# Access Compliance Report

## Public Rights-of-Way

### (Curb Ramps)

Intersection ID: 22038	Main Street: DELPOND_LN	Cross Street: MIRABELL_RD	Location: S
ADA ID: BABD1B770E21	Ramp Type: Perp	Initial Pass/Fail: Fail	Overall Compliance: No
Codes/Mitigation Info/Possible Solution		Field Measurements/Component Compliance

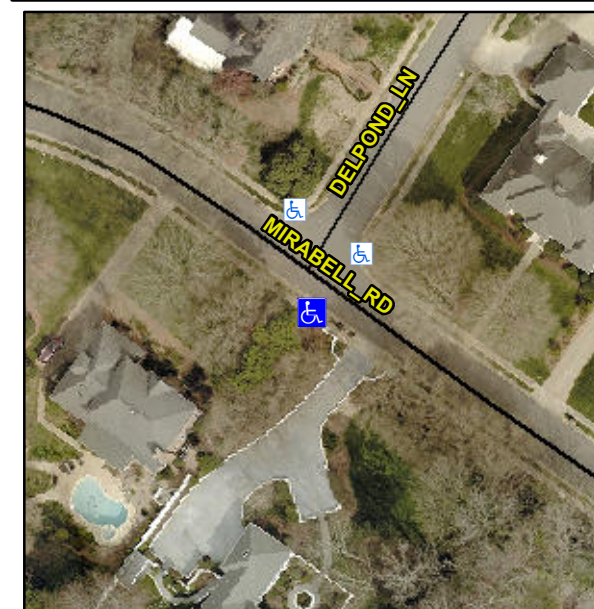
**Not Found, R304.5.1, R304.5.3**

Compliance	Description	Data	Compliance	Description	Data
N/A	Ramp Length (in)	82.0	Yes	Ramp Slope (%)	6.1
No	Ramp Width (in)	47.0	No	Ramp XSlope (%)	5.3
N/A	Flare Type LT	N/A	N/A	Flare Type RT	N/A
N/A	Flare Slope LT (%)	N/A	N/A	Flare Slope RT (%)	N/A
N/A	Flare Traversable LT?	N/A	N/A	Flare Traversable RT?	N/A
N/A	Landing Length (in)	N/A	N/A	DWS Provided?	N/A
N/A	Landing Width (in)	N/A	N/A	DWS Contrast?	N/A
N/A	Landing Slope (%)	N/A	N/A	DWS Length (in)	N/A
N/A	Landing X Slope (%)	N/A	N/A	DWS Full Width?	N/A
N/A	Landing Curb? (Y/N)	N/A	N/A	DWS Offset (in)	N/A
N/A	Shared Landing?	N/A			
N/A	Gutter Ponding?	N/A	N/A	Gutter Slope (%)	N/A
N/A	Gutter Lip Ht (in)	N/A	N/A	Gutter X Slope (%)	N/A
N/A	Painted X Walk1?	No	N/A	Painted X Walk2?	N/A
	X Walk 1 Direction	To NE		X Walk 2 Direction	N/A
N/A	X Walk 1 Width (in)	N/A	N/A	X Walk 2 Width (in)	N/A
	X Walk 1 Slope (%)	6.0		X Walk 2 Slope (%)	N/A
	X Walk 1 X Slope (%)	3.6		X Walk 2 X Slope (%)	N/A

**Remove & Replace Entire Ramp.**
